Balfour Beatty Construction, LLC, Appellant,

AMENDED RECORD ON APPEAL - VOLUME 8 OF 20

REQUEST FOR CHANGE ORDER
ONTINUED14-1278
Hotel @ Marion Square

Re: Request for Change Order # 199R3
Patisserie Stone and Tile Revisions

EXPANDED 1st FLOOR PLAN
SCALE 1/8" = 1'-0"

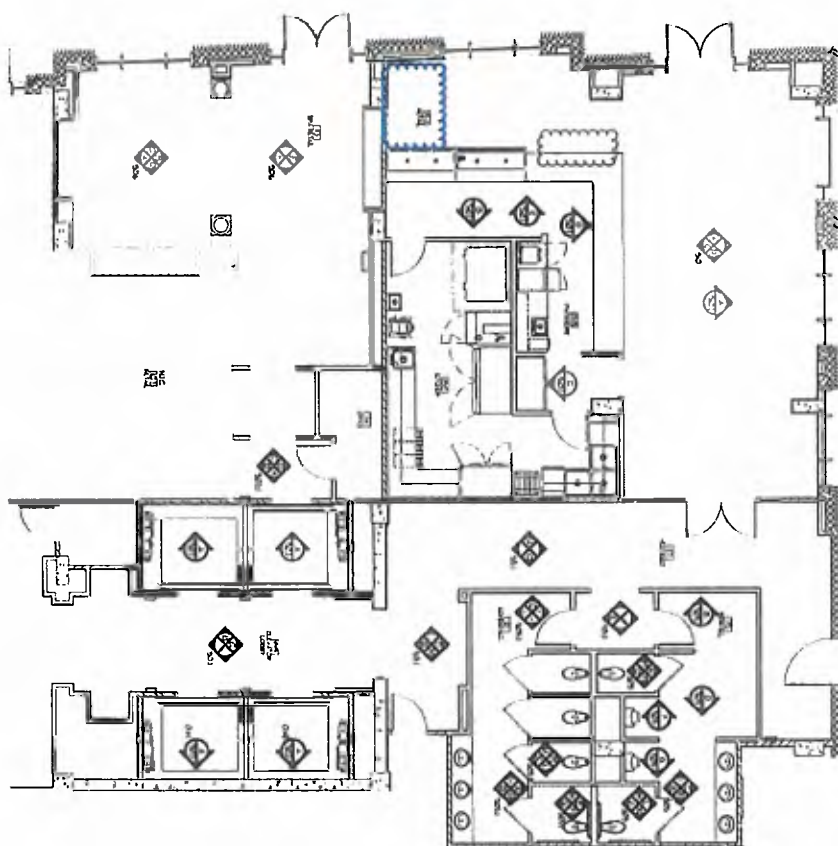
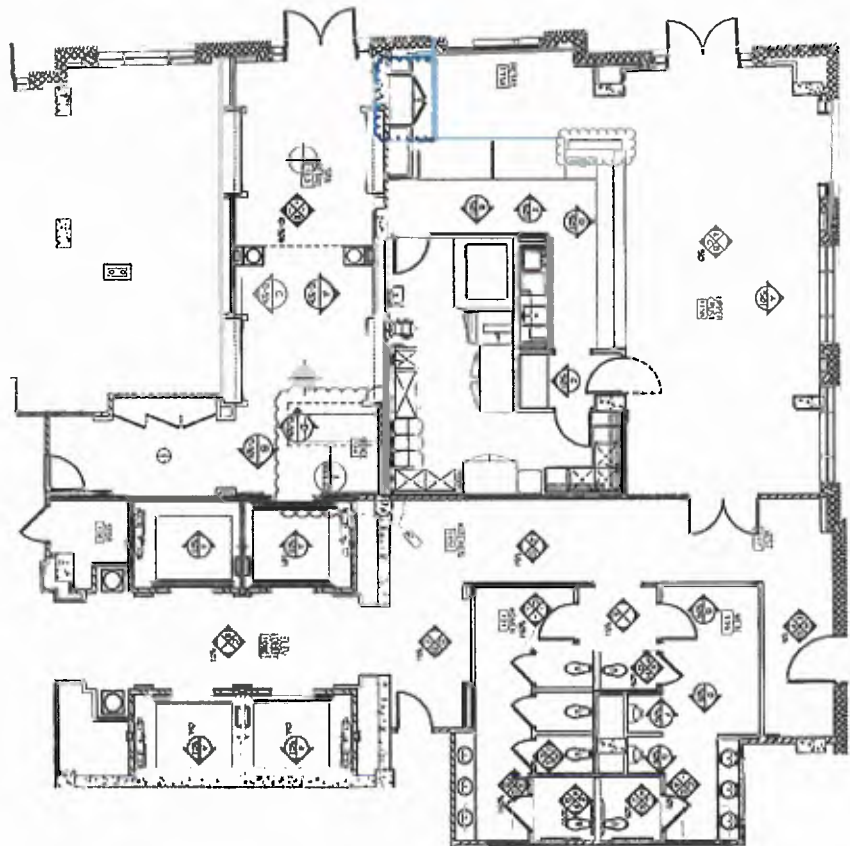
- Reconcile ST-01 Allowance at Patisserie Only – **(-\$2,150)**
 - Credit GMP Allowance (Calacutta Gold)
 - Add ST-01 final stone selection (2CM White Carrera Vitoria)

- Add mitered corner details at Patisserie countertop (cost includes miters at added casework)
- Add Casework at South Patisserie Wall - **\$1,850**
 - Casework feature was added in MOD revisions. This proposal is for the ST-01 material only. The casework item has been submitted under a different change order (RCO 180). Please reference the item clouded in blue on the back up proposal.

- Add Second Tier Shelf at West End - **\$790**
 - Add countertop at west end of Patisserie counter. Please reference the item clouded in green on the back up proposal.

- QT-01 Reconciliation - **\$605**
 - Change QT-01 Tile Selection from Ponce Steel Blue at GMP to the Tile Napoli Clementine Pattern on the finish schedule issued in SI 52. Cost includes added granite thresholds on detail 8/ID-990.

Request for Change Order # 210-- SI 54 Tile Revisions - Entry Foyer

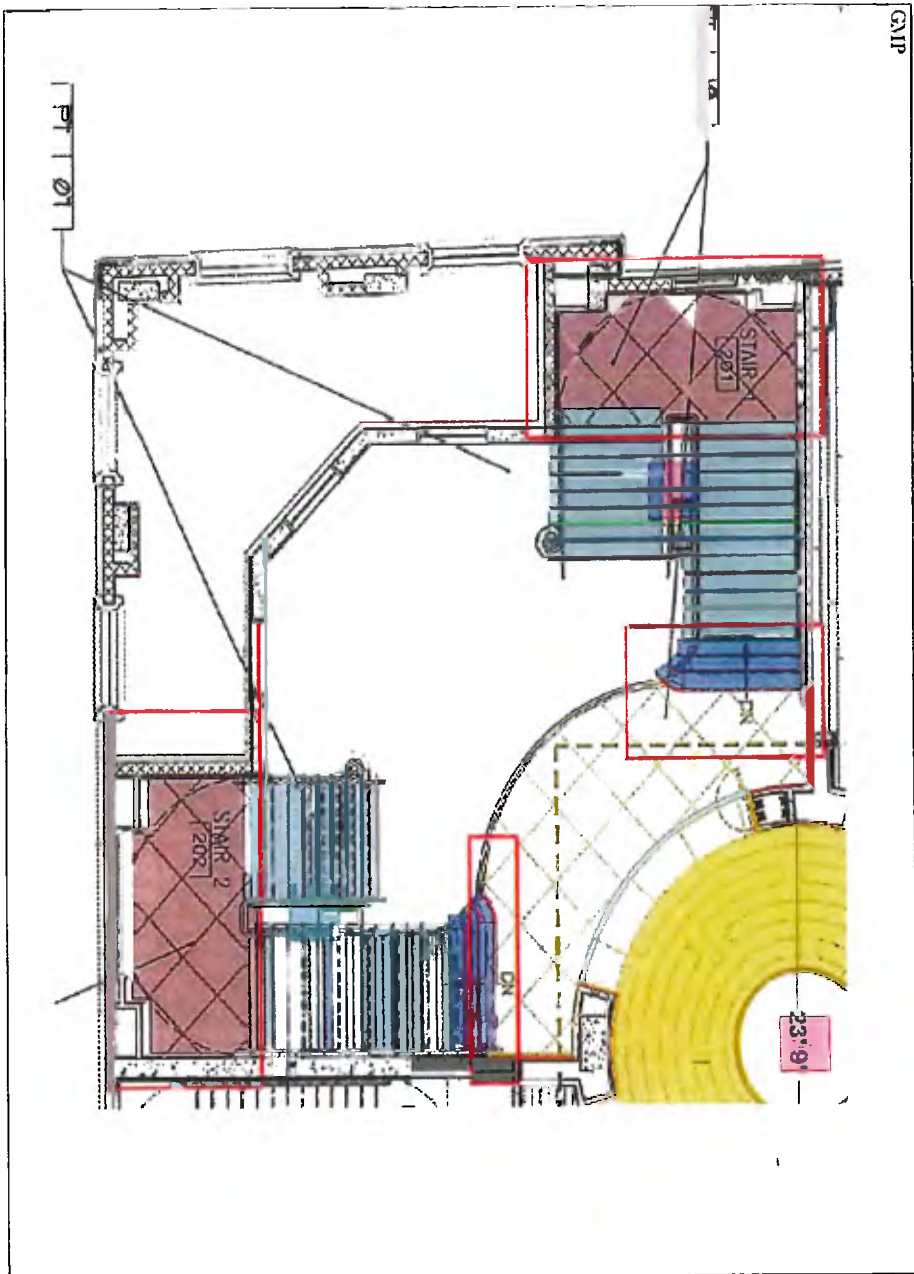
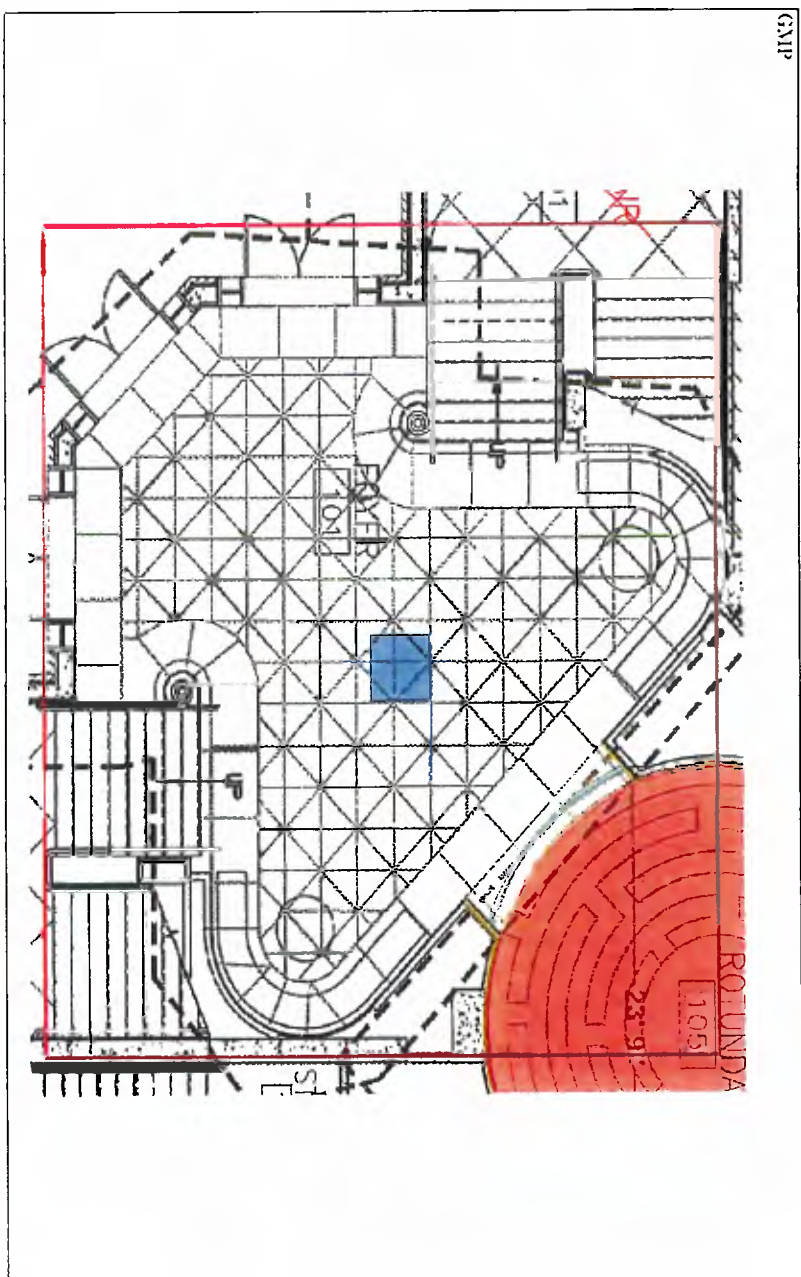
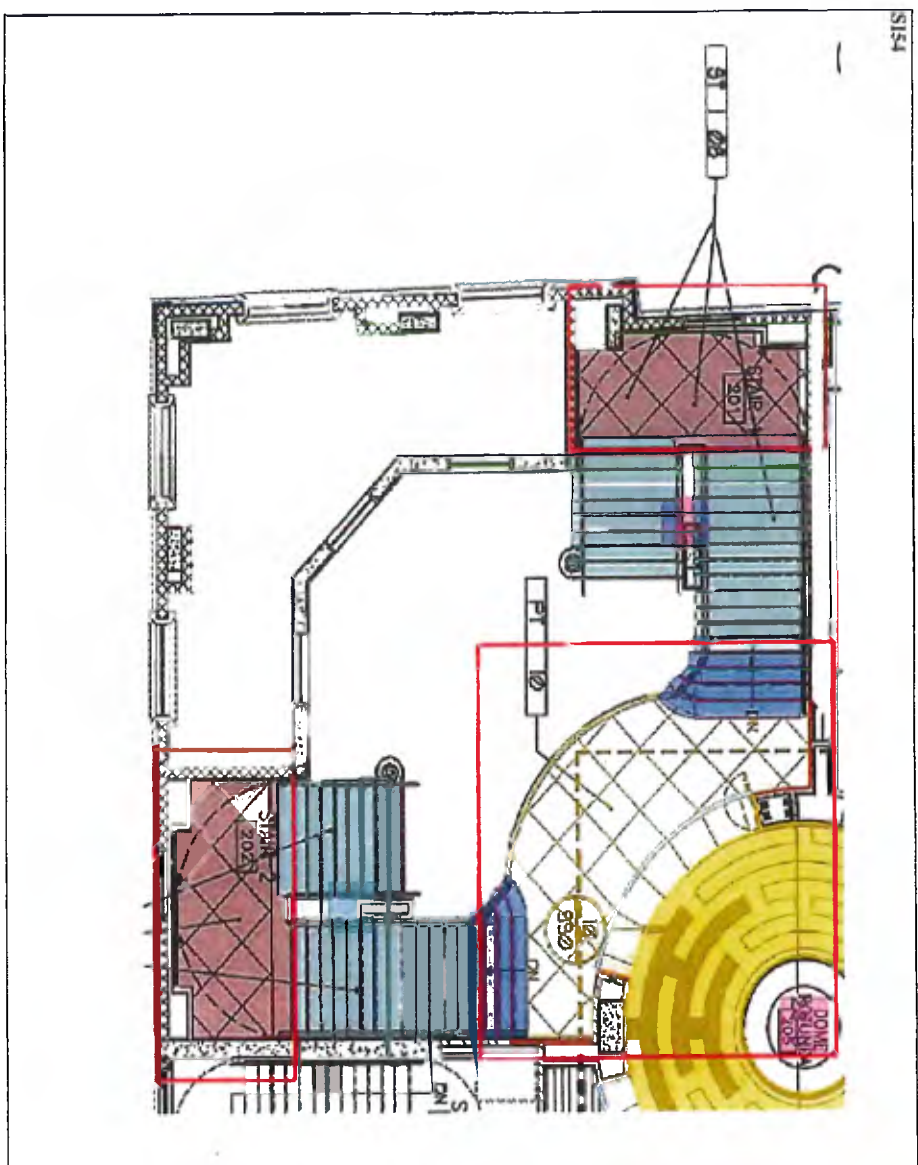
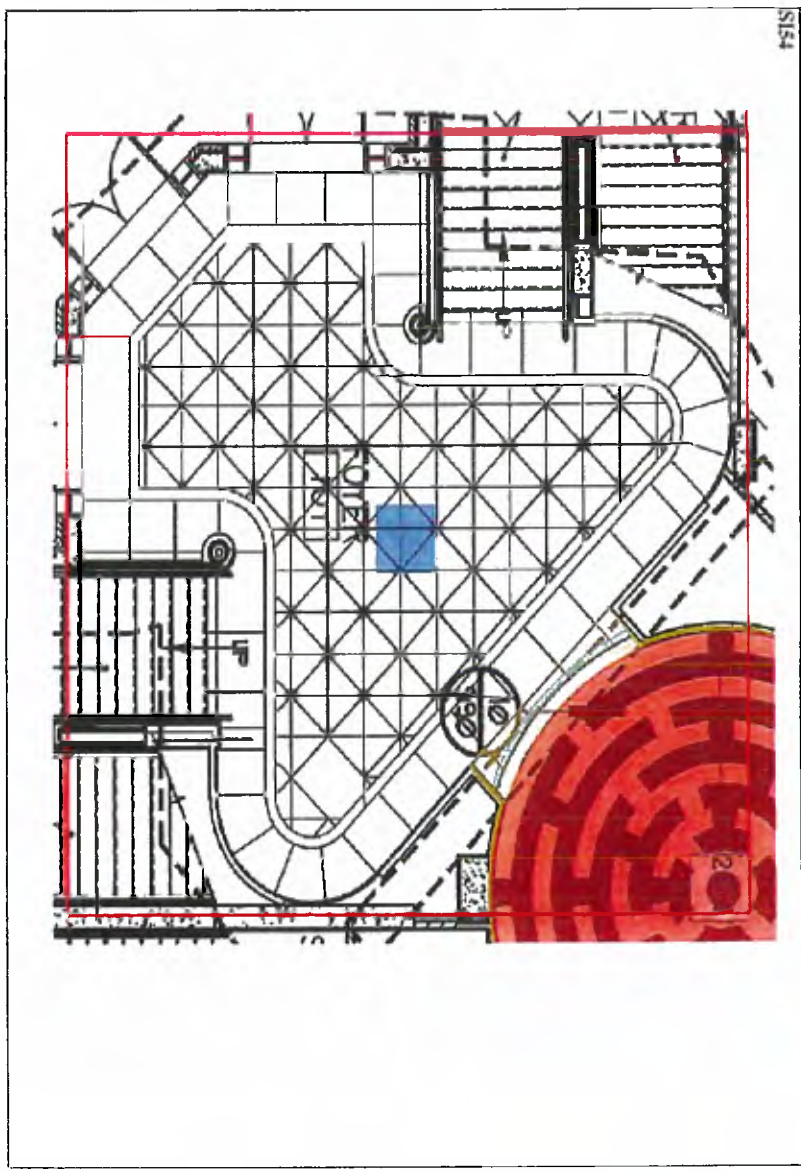
- Add ST-03 Accent Band - **\$1,800**
 - o Credit 80 SF of PT-10 Tile – (\$1,454) or (\$18.18/SF) – SF Includes Waste Factors
 - o Add 53 SF of ST-03 Accent Band - \$3,000 or \$56.64/SF
- Revise Stair Landings from PT-10 to ST-08 - **\$2,180**
 - o Credit 222 SF of Tile – (\$2,427) or (\$10.95/SF)
 - o Add 222 SF of ST-08 – \$4,529 or \$20.40/SF
- Add ST-08 “Treads” at Intermediate and Stop Landing - **\$1,720**
 - o Credit Original Count of Stair Risers and Treads – (\$27,851) or (\$580/Step)
 - o Add Current Count of Stair Risers and Treads – \$29,346 or \$565/Step
- Revise Shop Drawings to SI 54 - **\$230**
 - o Original shop drawings were rejected to conform to SI 54 which was not released at time of shop drawings.
- Additional Freight - **\$210**

- Changed landings from PT-10 to ST-08
- Changed entry floor design to add accent between triangle cut and straight grid
- Added stair tread/riser at top landing of both sets of grand staircases

6 ENLARGED DETAIL:

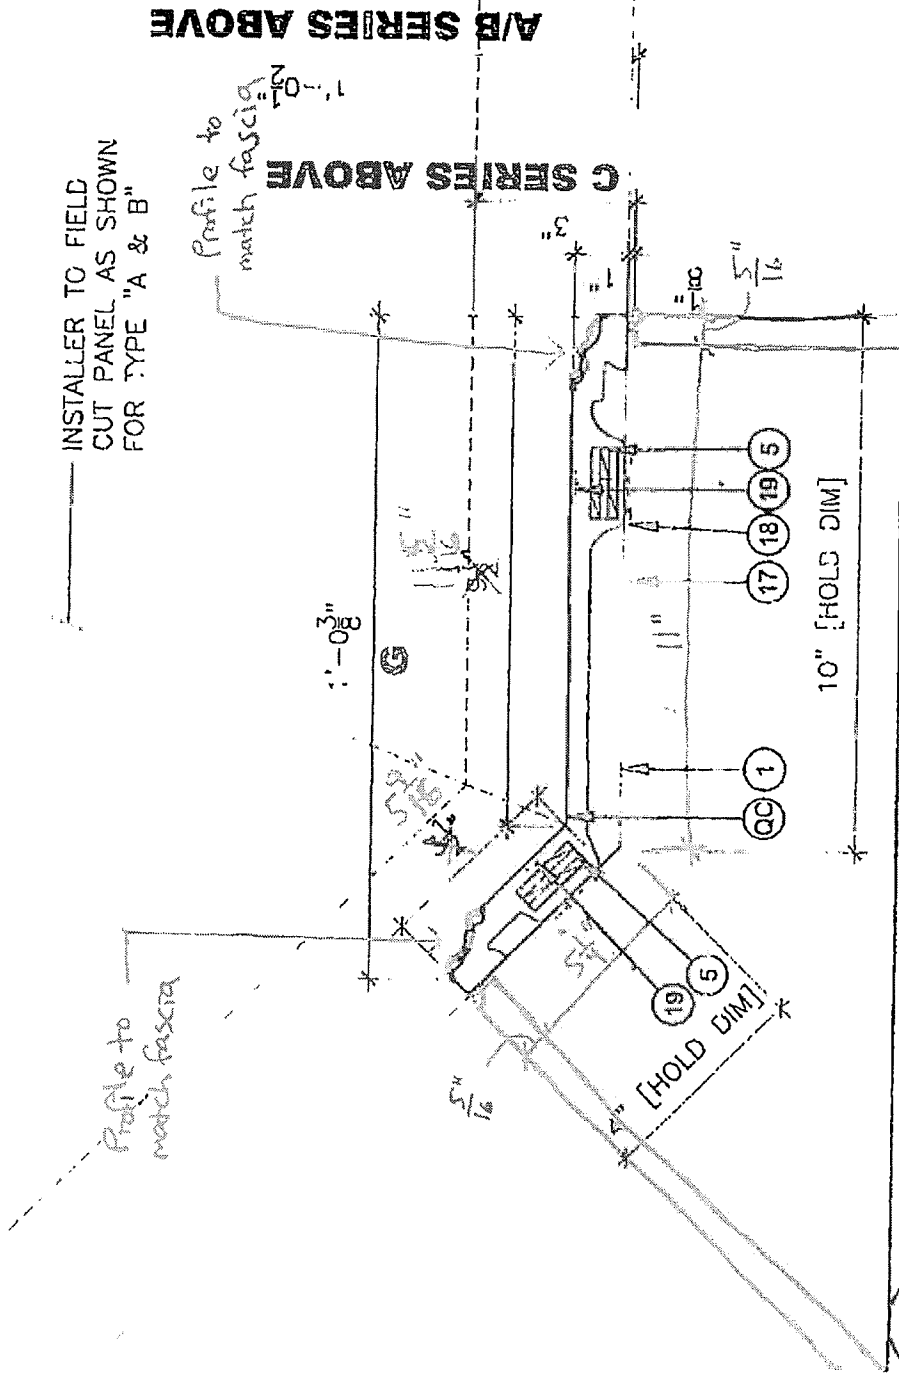
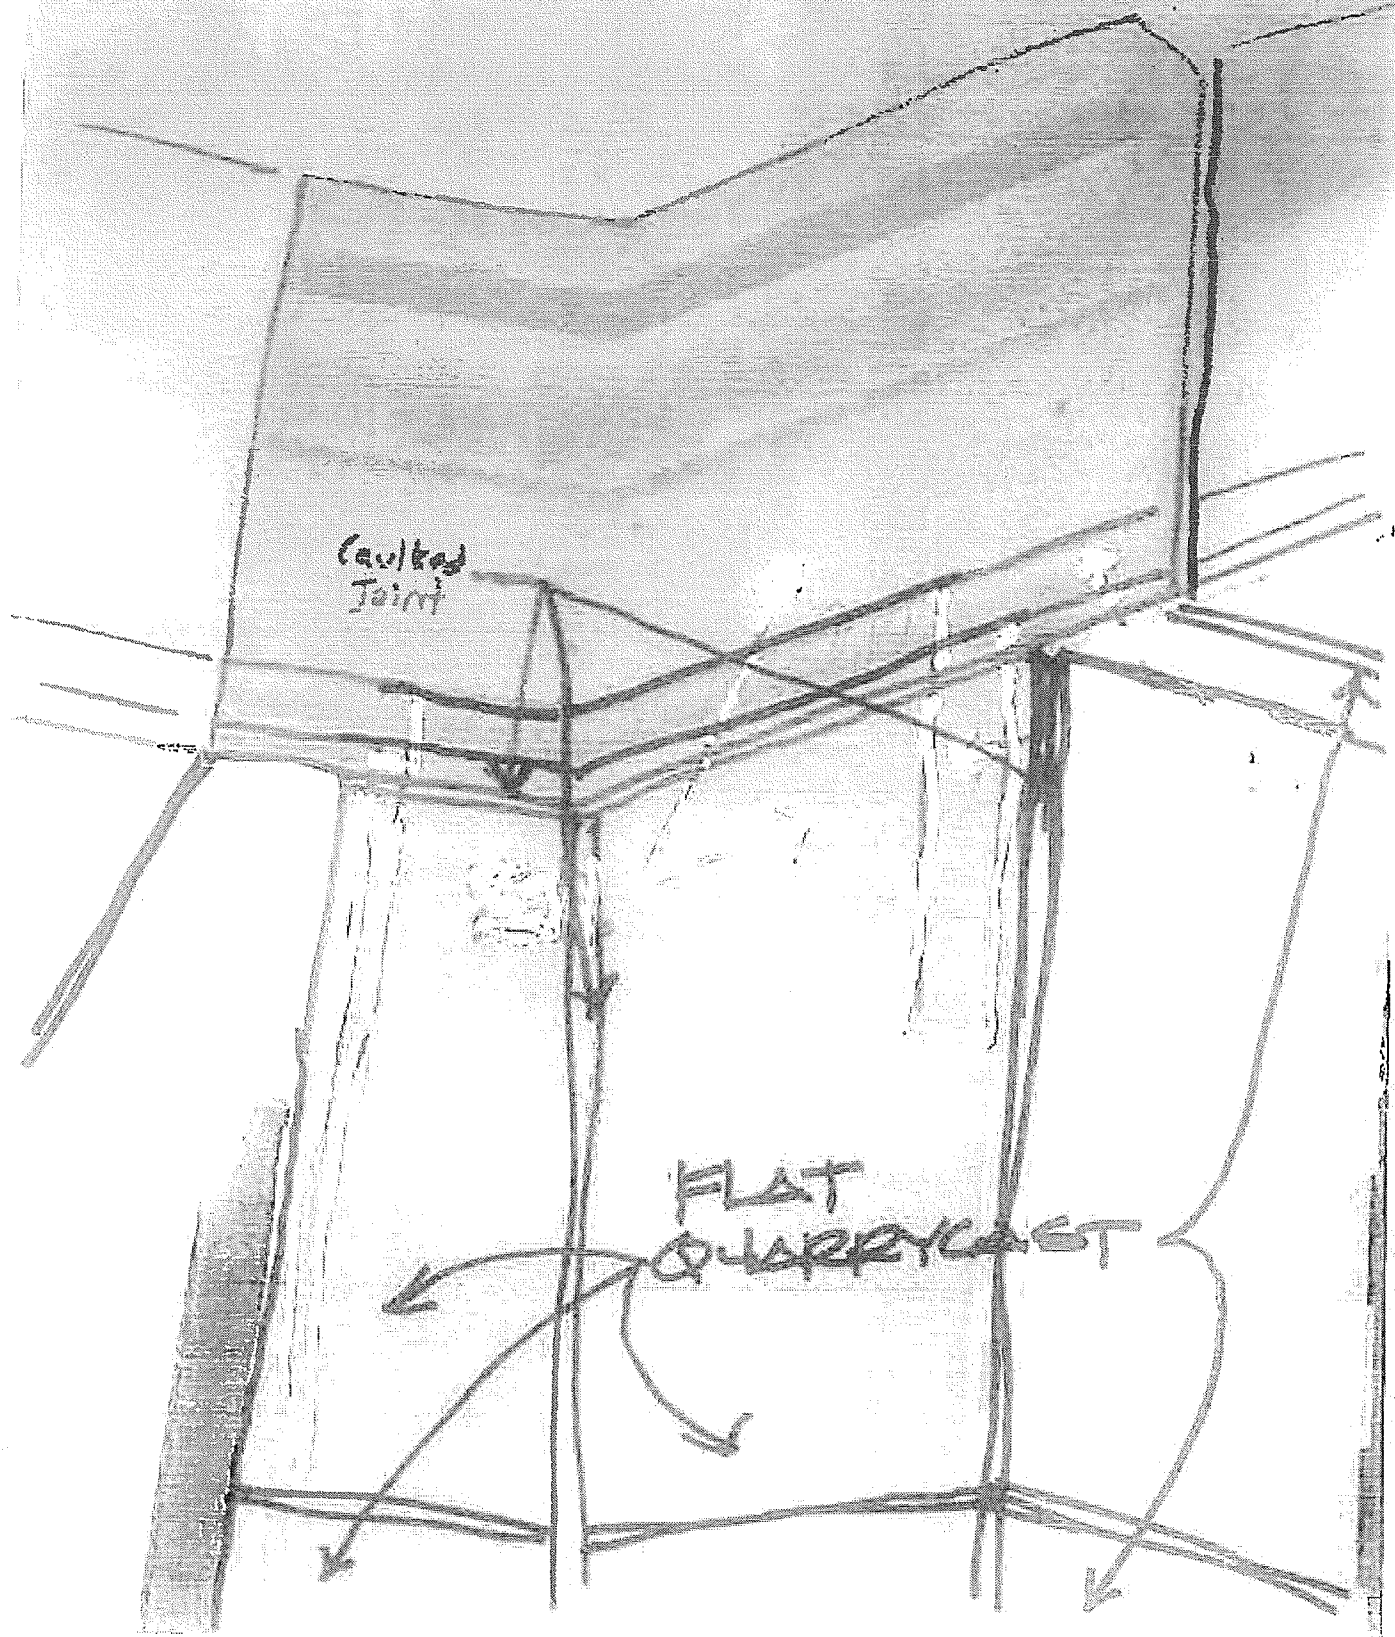
INSTALLER TO FIELD
CUT PANEL AS SHOWN
FOR TYPE "A & B"
